UNITED STATES PATENT AND TRADEMARK OFFICE

APPLICATION NO.	FILING DATE	FIRST NAMED INVENTOR	ATTORNEY DOCKET NO.	CONFIRMATION NO.
10/085,847	02/27/2002	William B. Dragan	P-2354.CIP2	1763

Office Action Summary	Application No. 10/085,847	Applicant(s) DRAGAN ET AL.	
	Examiner Todd E. Manahan	Art Unit 3732

DETAILED ACTION

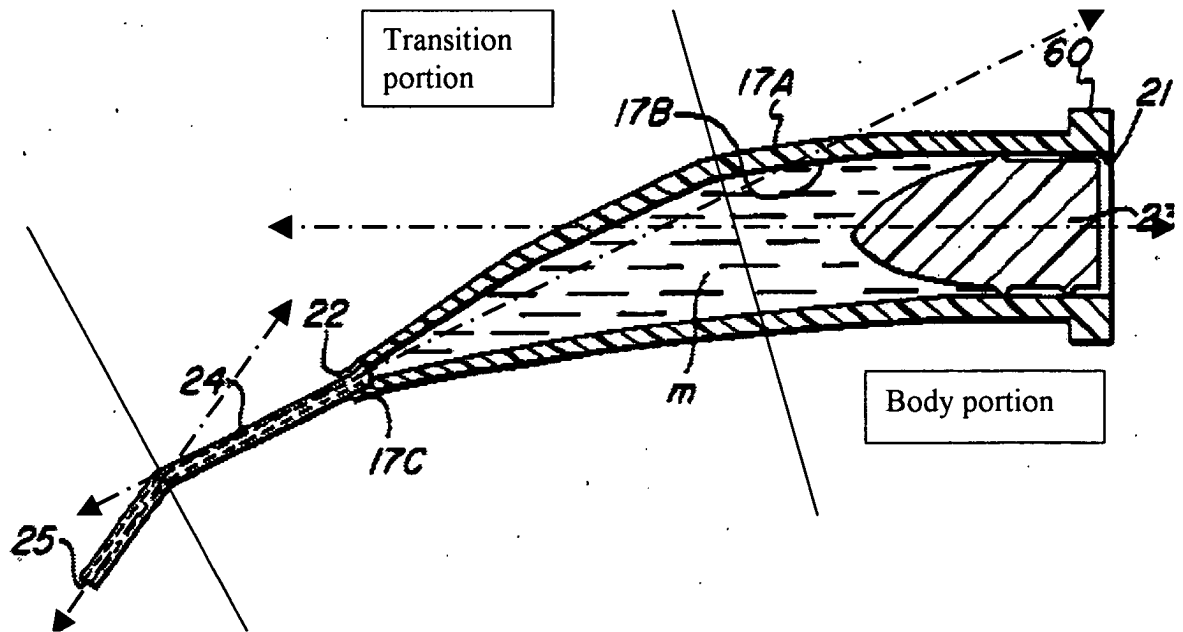
Claims 1, 4 and 10 are rejected under 35 U.S.C. 102(b) as being anticipated by Discko, Jr. (United States Patent No. 5,165,890).

Discko, Jr. discloses a dental capsule providing comprising: a body portion 330 having a substantially constant first inside diameter and a body portion axis; a transition portion 340, adjacent said body portion, having a reducing inside diameter and a transition portion axis; and a discharge portion 332 having a substantially constant second inside diameter, adjacent said transition portion, and having a discharge portion axis. Said body portion axis intersects said translation portion axis forming a body-transition angle (the angle being 0 degrees) and said transition portion axis intersecting said discharge portion axis forming a transition-discharge angle. A flange 326 is attached to the body portion (see figure 5).
